MANCHESTER
CITY COUNCIL

Delegated officer report for planning application

Application no.	140004/LP/2024
Date registered valid:	14 May 2024
Proposal:	Installation of rear dormer
Address:	Citi Place, 1384 Ashton Old Road, Manchester, M11 1JU
Ward(s):	Clayton & Openshaw Ward
Applicant:	Mr Dominic Salami
Agent (if any):	Mr Abdul Hadi Sabawan
Case officer:	Robert Tyrer Tel: 0161 234 4068 Email: robert.tyrer@manchester.gov.uk
Recommendation:	Refuse
Date of recommendation:	6 December 2024

Image 1 Comparison of proposed and existing rear elevation windows.

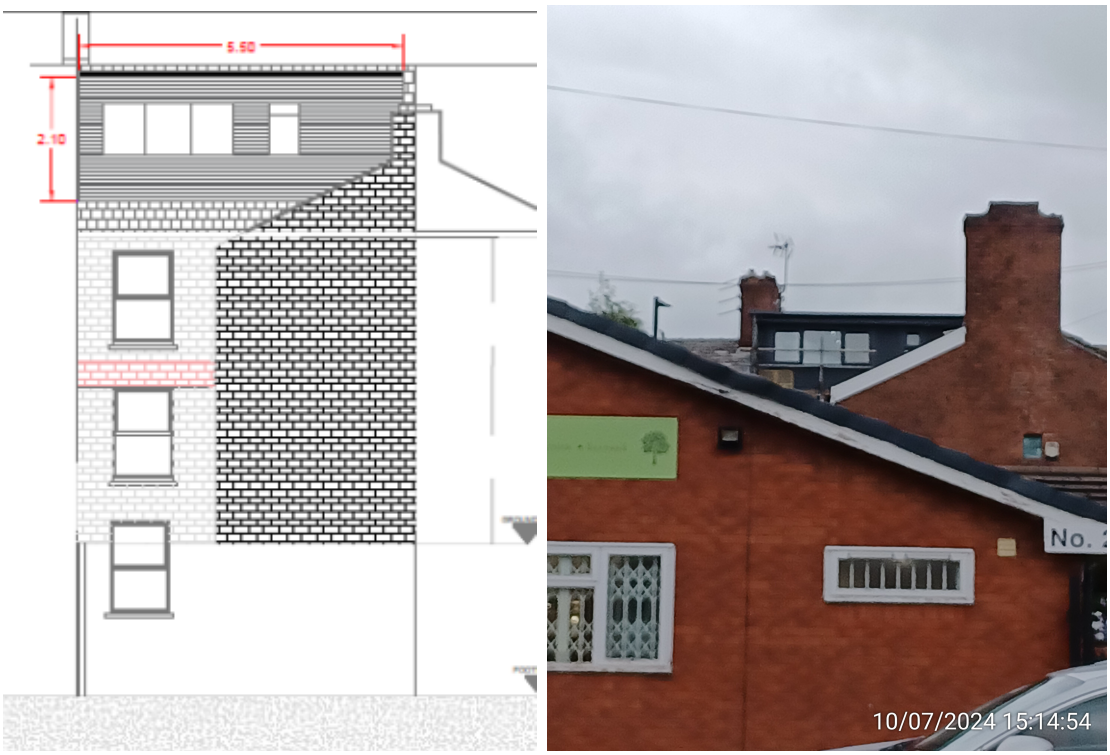
B.2 (a) the materials used in any exterior work must be of a similar appearance to those used in the construction of the exterior of the existing dwellinghouse;	No

During the course of the application, the applicant informed that the composite cladding on the dormer face had been painted to match the colour of the roof tile. A comparison of before and after can be seen on image 2. In terms of the material, the face and sides of a dormer window should be finished using materials that give a similar visual appearance to existing house. So, the materials used for facing a dormer should appear to be of similar colour and design to the materials used in the main roof of the house when viewed from ground level. Whilst the applicant has now painted the horizontal cladding a colour to match the roof tiles, to be of similar in visual appearance the cladding should have vertical lines to match the roof tile and not horizontal as installed. A consequence of painting the dormer now highlights the windows that have been installed in the face of the dormer. The Permitted Development Rights for Householders – Technical guidance 2019 provides further explanation in that "Window Frames should also be similar to those in the existing house in terms of their colour and overall shape", In this case the frame colour is darker than the white fenestration on the existing house and the windows are smaller in size.

1) The face windows and face materials for the proposed dormer as on drawings titled "PROPOSED FLOOR PLANS & ROOF PLANS", "SITE PLAN", "EXG & PROPOSED ELEVATION PLANS" and "EXG FLOOR PLANS" would not meet the requirements of Part 1, Schedule 2, Class B.2(a) of the Town and Country Planning (General Permitted Development) (England) Order 2015 (as amended), as they would not have a similar visual appearance to those used in the construction of the exterior of the existing dwellinghouse.

The overall size, fenestration and colour of the window proposed to be installed on the face of the rear dormer would not be similar in design to the windows used in the construction of the exterior of the original dwelling and would not meet the requirements of Part 1, Schedule 2, Class B.2(a)
